# TEXAS DEPARTMENT OF TRANSPORTATION

## MINOR DESIGN UPDATES UNDER CONSIDERATION FOR FINAL DESIGN

## CROSS STREET IMPROVEMENTS

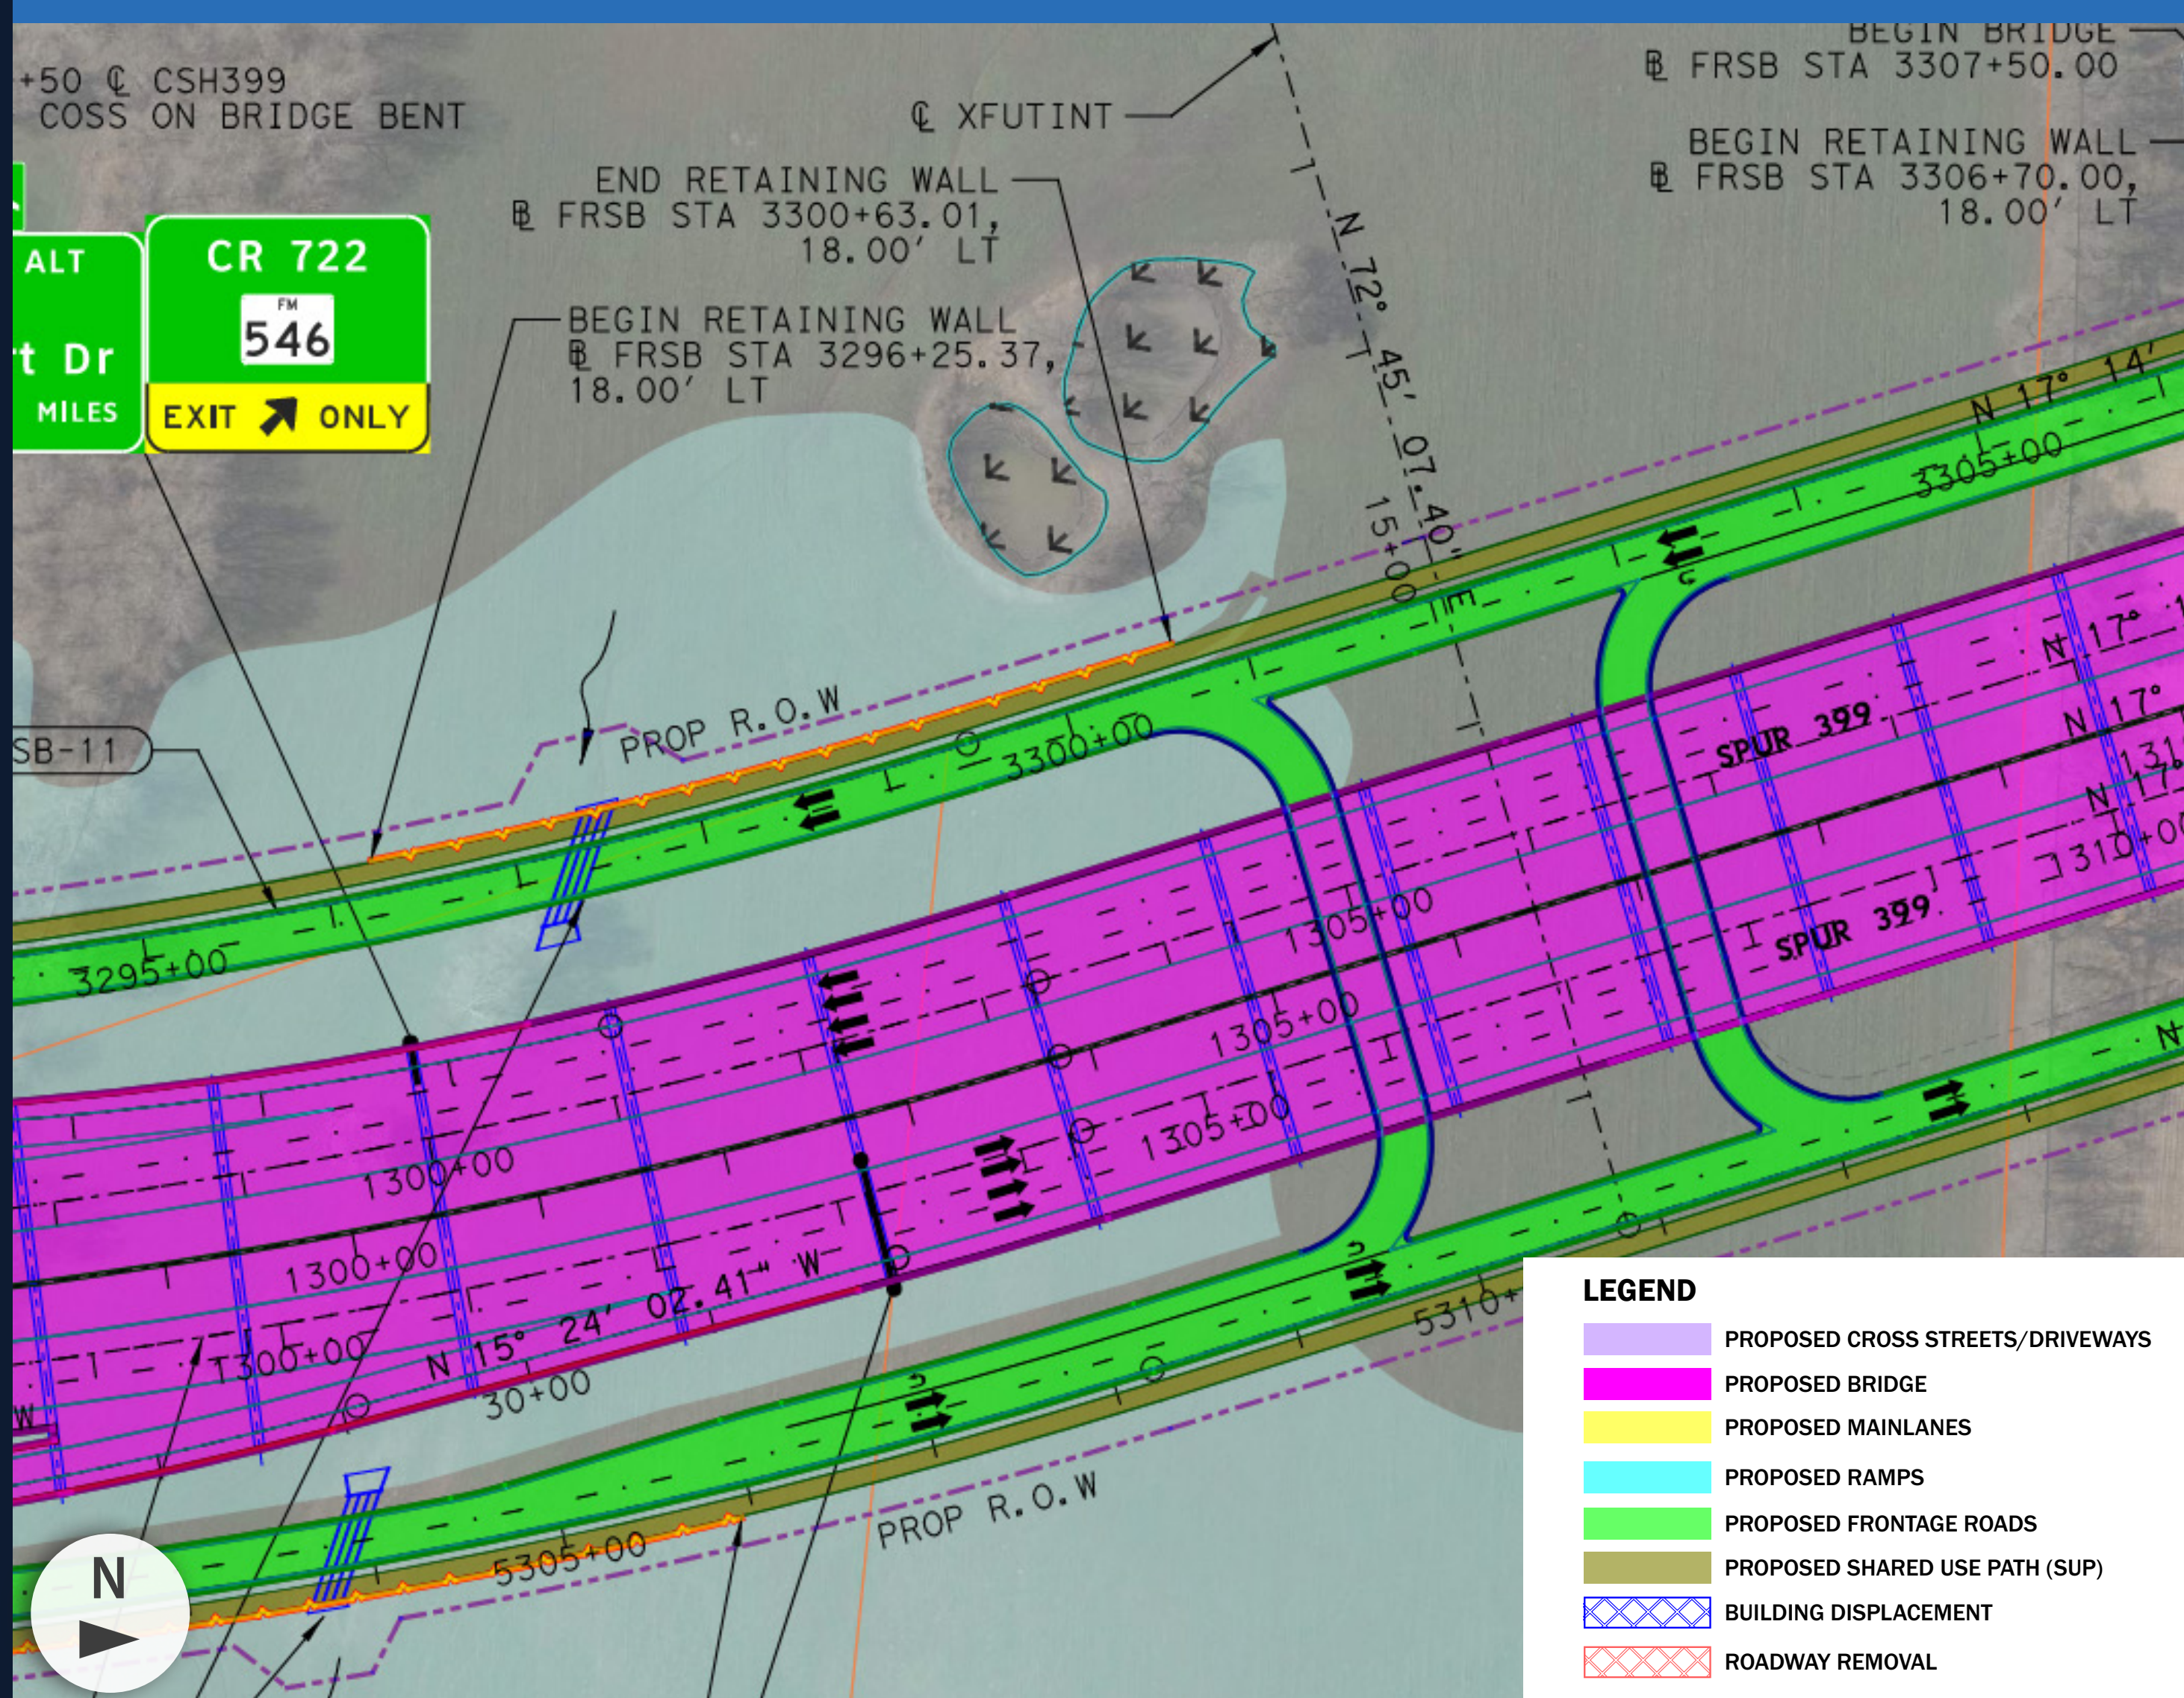
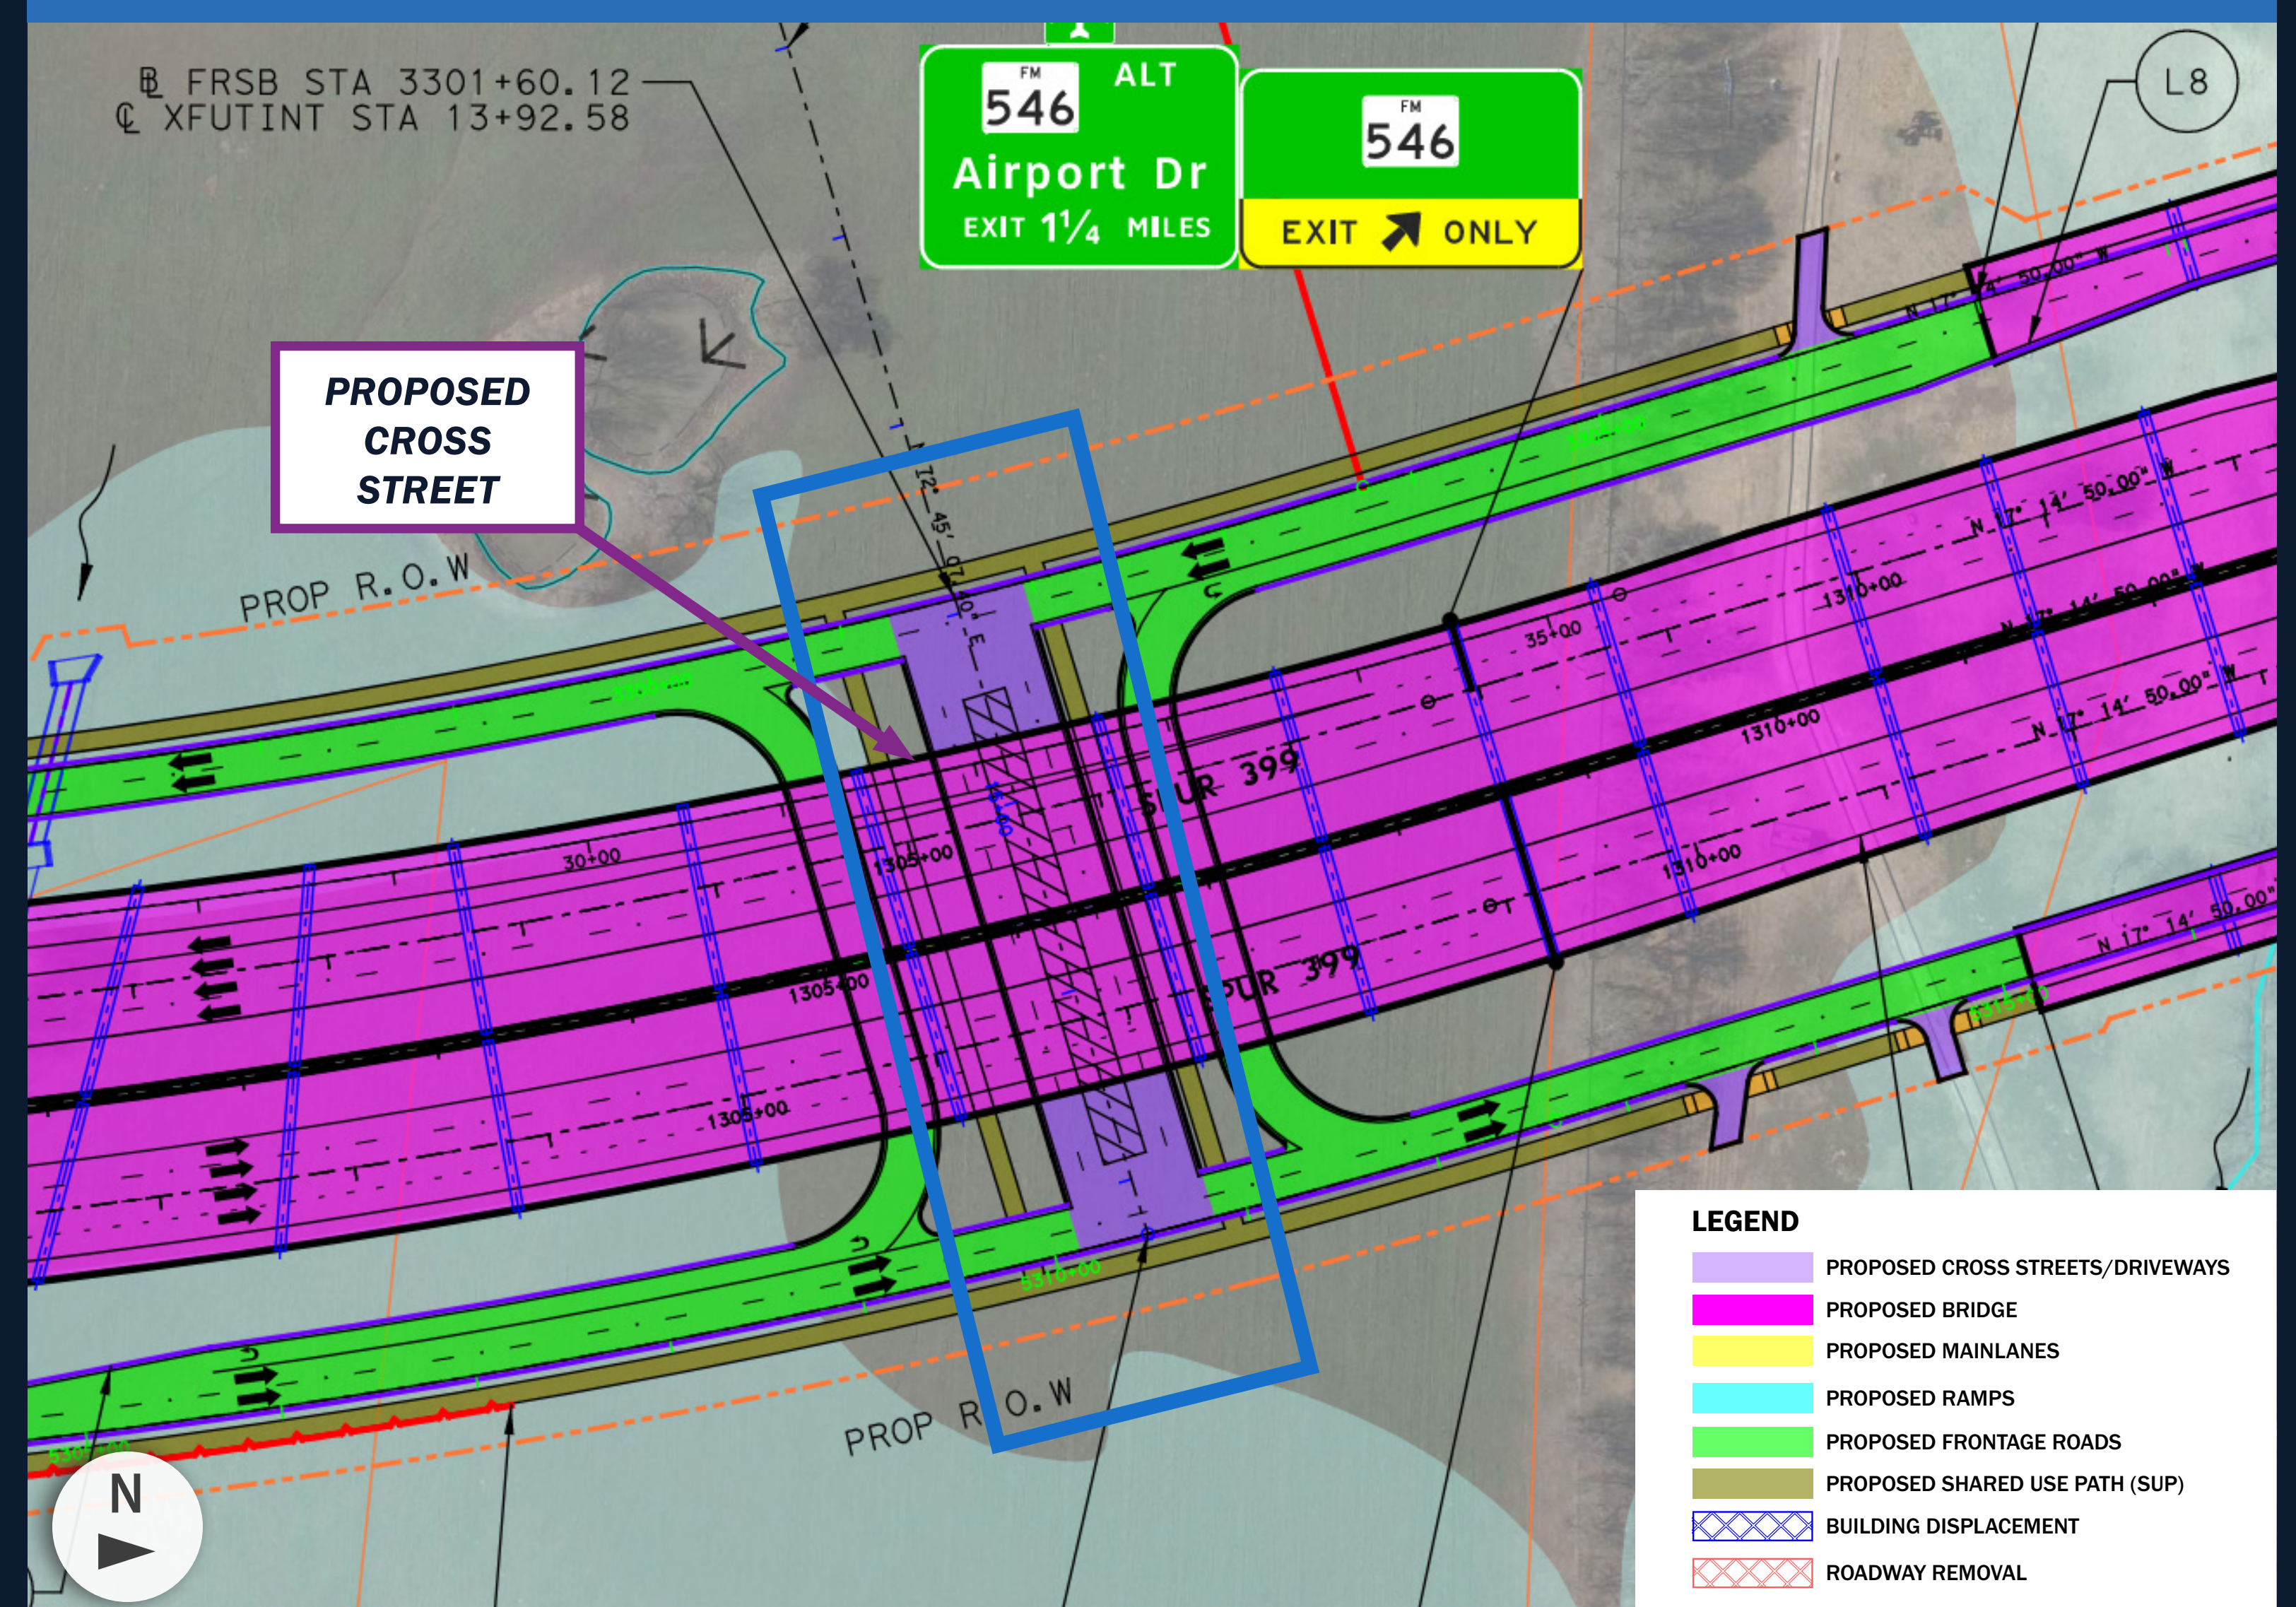
TxDOT is considering design updates to the plans you see on the schematic roll plots. Design updates will be made after this Public Hearing in consideration of public comments received and included in the FEIS. The information below details a change under consideration for the project's final design.

The proposed design would construct a crossing under the bridge section to provide an east-west connection near McKinney National Airport.
